Item Name: AS350/AS355 Quick Release Heli-Utility-Basket™ Long, Heavy Duty Lid

DART SERVICE INSTRUCTION

TO AMEND INSTALLATION INSTRUCTIONS D350-607-3 Rev.D,

DRAWING NO. DSI 9699

FIGURE 1: INSTALLATION OF D4775-041 FWD STRUT

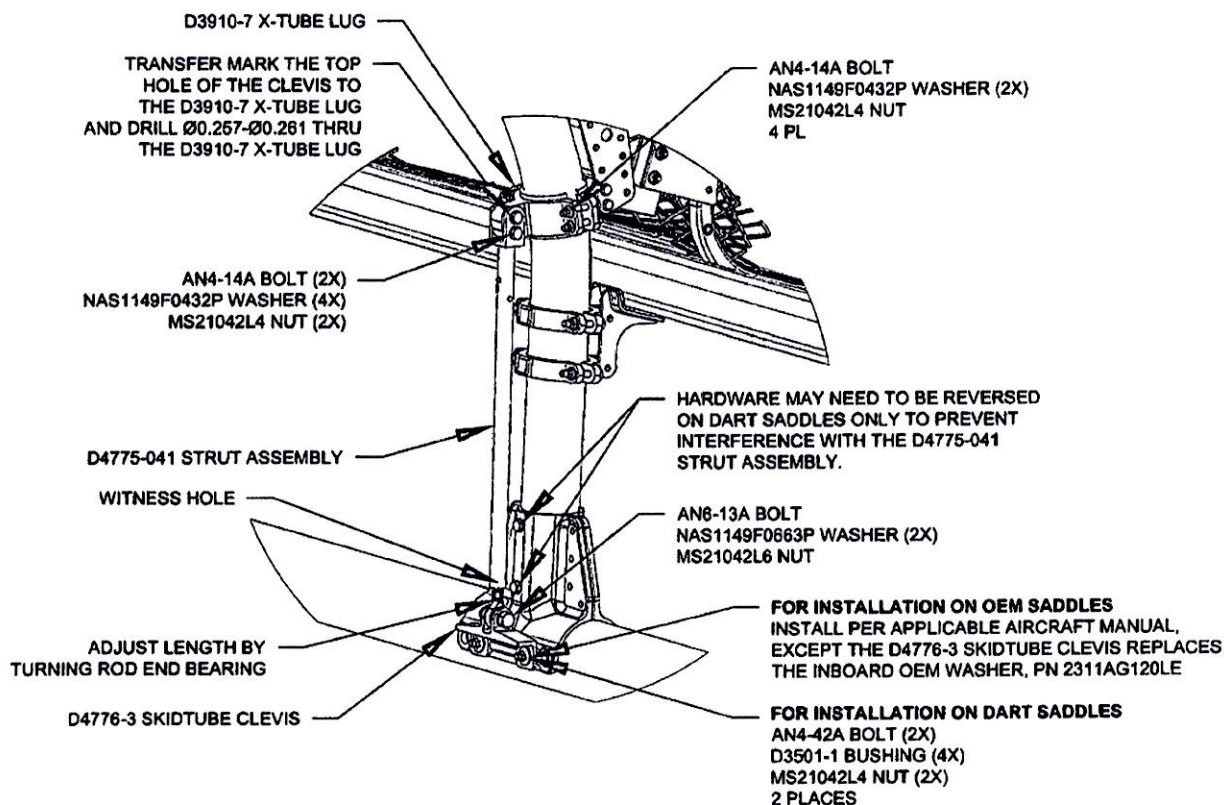
3.1 Substitute the Forward Lower D3910-5 X-Tube Lug with the D3910-7 X-Tube Lug as shown in Figure 1.

3.2 Install the forward D4775-041 Strut Assembly. Transfer mark from the upper hole on the clevis of the D4775-041 Strut Assembly to the D3910-7 X-tube Lug and drill thru the lug $\varnothing 0.257$ - $\varnothing 0.261$ as shown in Figure 1. Touch up chemical conversion coating per MIL-DTL-5541. Check the witness holes located at the bottom end of the D4775-041 Strut Assemblies to ensure that the thread from the rod end extends past the witness hole.
Torque MS21042L4/-4 nuts to 50-70 in-lbs (5.7-7.9 N-m). Torque MS21042L6/-6 nuts to 160-190 in-lbs (18.1-21.5 N-m).
